TOWN OF PLYMOUTH

ADDENDUM 1

RE: 21615, Water Street Promenade-Southern Section

THE FOLLOWING CHANGES AND/OR ADDITIONS/DELETIONS MODIFIES THE BID DOCUMENT

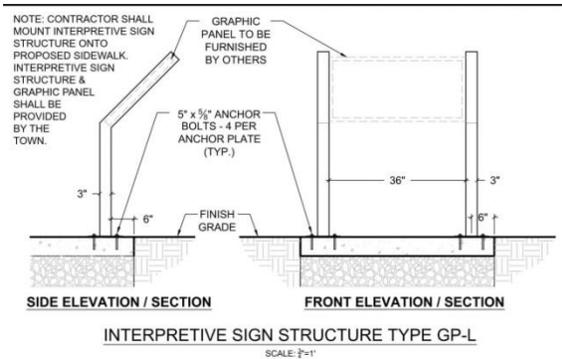
Q6. Page 14 of the Construction Plans denotes R & R Iron Range (Item 101.15). Please elaborate on this item of work, and are there any Construction Details that can be forwarded for same.

Response: Here is a photo of the Iron Ranger (blue colored object)
